Liberty Mill Road, Preliminary Plan Amendment No. 12017021C

Completed: 10/15/2021

Request to amend the Preliminary Plan for the creation of one 3.59-acre lot for a Residential Care Facility (Over 16 persons) with up to 125-beds (associated with Conditional Use 20-09).

Figure 10 – Onsite Stream Valley Buffer

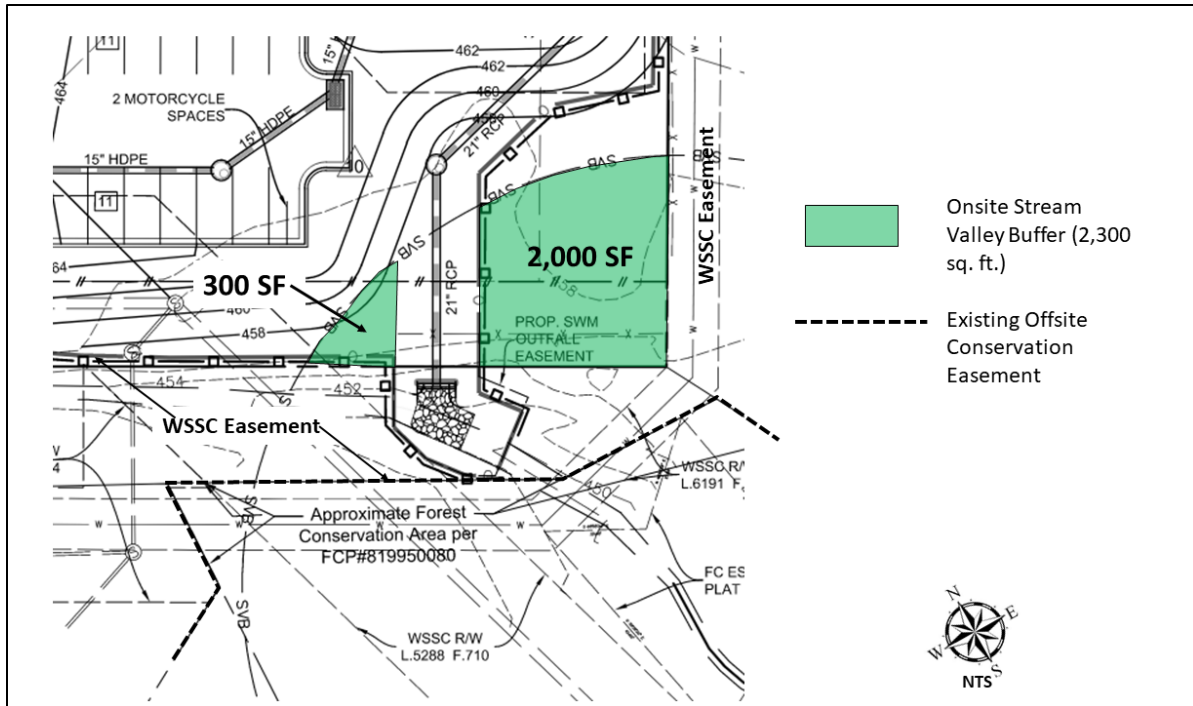
The approved NRI/FSD and the FFCP approved with the Preliminary Plan both show a small segment of SVB on the Subject Property in the southeast corner of the site of about 2,900 sq. ft. (0.07 acres). The original FFCP showed no encroachments into the SVB. However, the current FFCP Amendment shows a SWM outfall and easement in the area of the SVB (Figure 10). This SWM outfall and easement bisect the SVB and create two small segments of 300 sq. ft. and 2,000 sq. ft. that would typically be placed into a Category I Conservation Easement. In addition, the onsite SVB is disconnected from the main SVB of the intermittent stream by an existing WSSC easement along the southern property line of the Subject Property. In this very specific case, recording two small segments of standalone separate Category I Conservation Easements does not support the ecological concept of a Category I Conservation Easement. These small standalone Conservation Easement areas also create a very difficult condition to enforce. Therefore, as conditioned, the Applicant will not record a Category I Conservation Easement over the SVB on the Subject Property and will add the area of 2,300 sq. ft. (0.05 acres) of SVB to the 0.59 acre afforestation requirement on the amended FFCP resulting in a total FFCP requirement of 0.64 acres.

- c. Prior to Certified Final Forest Conservation Plan, the Applicant must revise the Amended Final Forest Conservation Plan ("FFCP") to show that the 2,300 square feet (0.05 acres) of stream valley buffer not being placed into a Category I Conservation Easement is being added to the FFCP Afforestation Requirement of 0.59 acres resulting in a total FFCP afforestation requirement of 0.64 acres.

Figure 11 – Protected Trees to be impacted

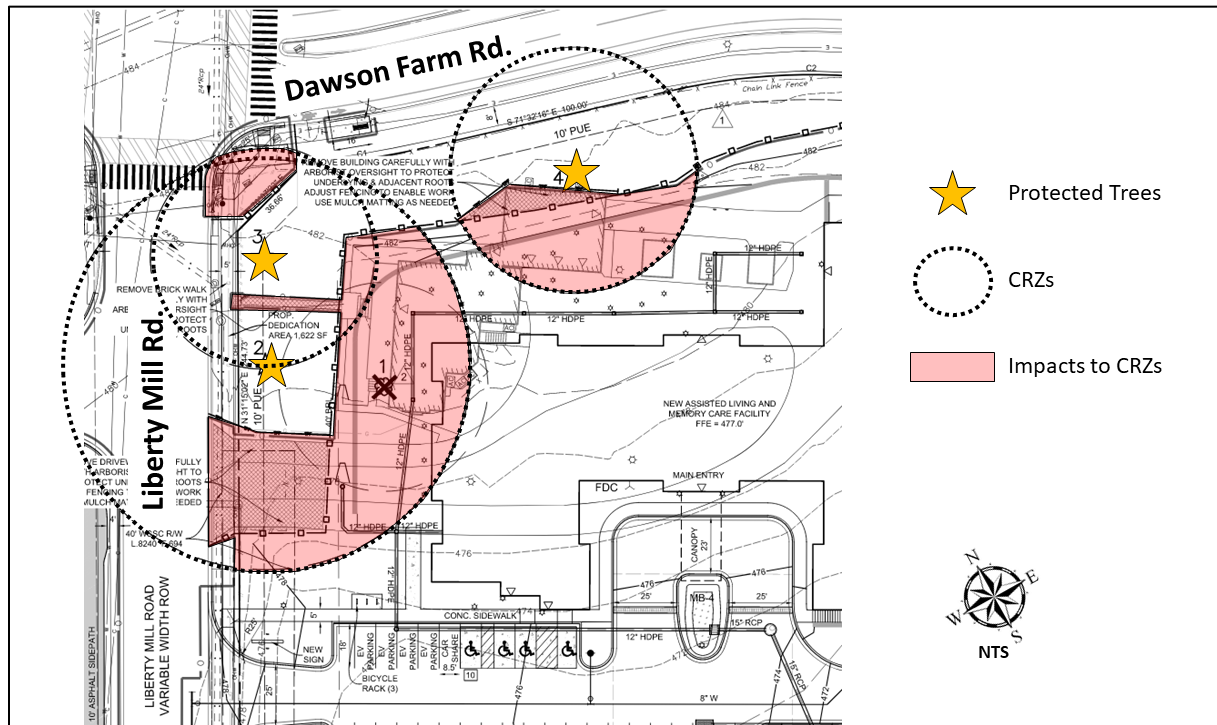
The Applicant submitted a variance request in a letter dated July 21, 2021 (Attachment H). The Applicant proposes to impact, but retain, three (3) trees that are 30 inches or greater DBH, that are considered Protected Trees under Section 22A-12(b)(3) of the County Forest Conservation Law (Figure 10).

Approved Landscape Plan (Ex. 47)

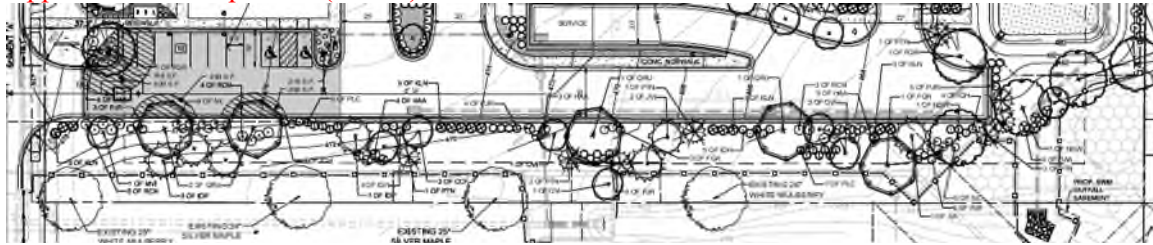
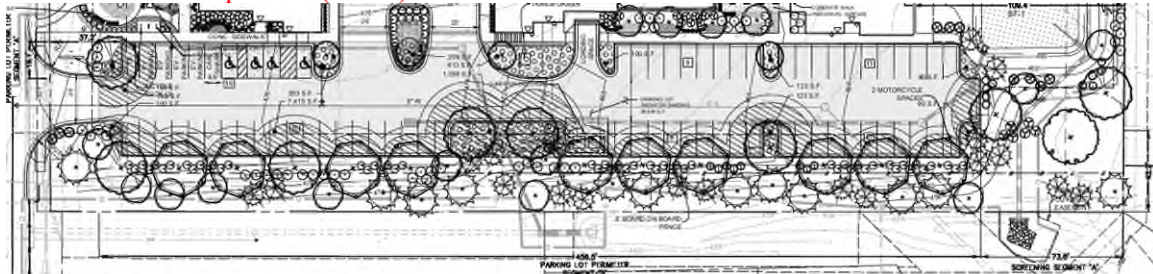
In addition, a 29' wide area between the southern edge of the parking facility and southern Property line will provide substantial year-round screening of the parking facility, dumpster enclosure and building through the strategic placement of specifically selected trees and shrubs (L2.01). The landscaping in this area consists of the Parking Lot Perimeter Landscaping (Segment B), Screening Segment A, Parking Lot Shade Trees and additional landscaping south of the Property entrance, which totals 46 shade, ornamental and evergreen⁷ trees and 103 deciduous and evergreen shrubs, which, coupled with the 8' fence, will prevent any vehicular headlight trespass, and constitute more substantial screening in this area than the approved landscaping, which provided 35 trees and 112 shrubs. *Id.*; See, OZAH Ex. 47. Furthermore, adherence to the parking lot shading and perimeter landscaping requirements triggered by the additional surface parking spaces, requires replacement of the 4 existing trees along the southern Property line, as reflected on the enclosed amended Forest Conservation Plan. (L8.02). The below plan excerpts clearly show the improvement to the landscape screening in this area:

⁷ The Petitioner made certain changes to the amended Landscape & Lighting Plan (L2.01) to accommodate Mr. Jacob's request to include more evergreen, rather than deciduous, trees along the parking facility perimeter confronting his and Mr. Shukla's properties.

Approved Condition Use Plan

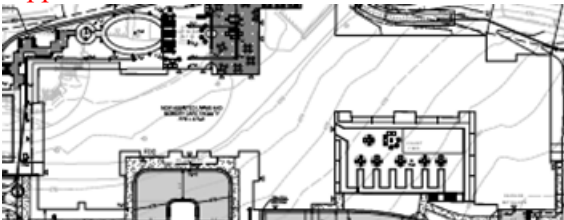
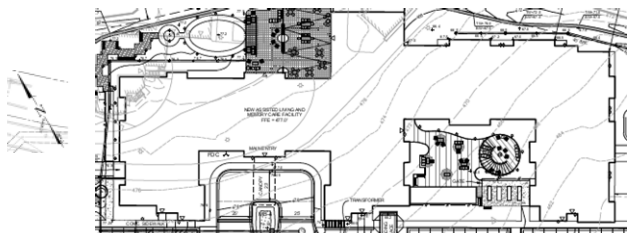
A slight variation in the building footprint, as depicted by the below side-by-side comparison, is also proposed:

Specifically, there is a slight reconfiguration to the west side of the footprint. The amendment reduces the eastern part of the building, thereby shifting the footprint towards the west and increasing the rear building setback from 93' to 109' feet. (CU2.01). The building projections added to certain locations on the southern building façade, however, cause the entire side yard setback to be reduced by 8' (101' to 93' feet), but practically, this only occurs at the projection locations. *Id.* The variation to the north side of the building footprint requires the retaining wall to be extended along the entire length of the north side of the residential care facility. *Id.* However, the height of the building is being reduced by 2'. *Id.*
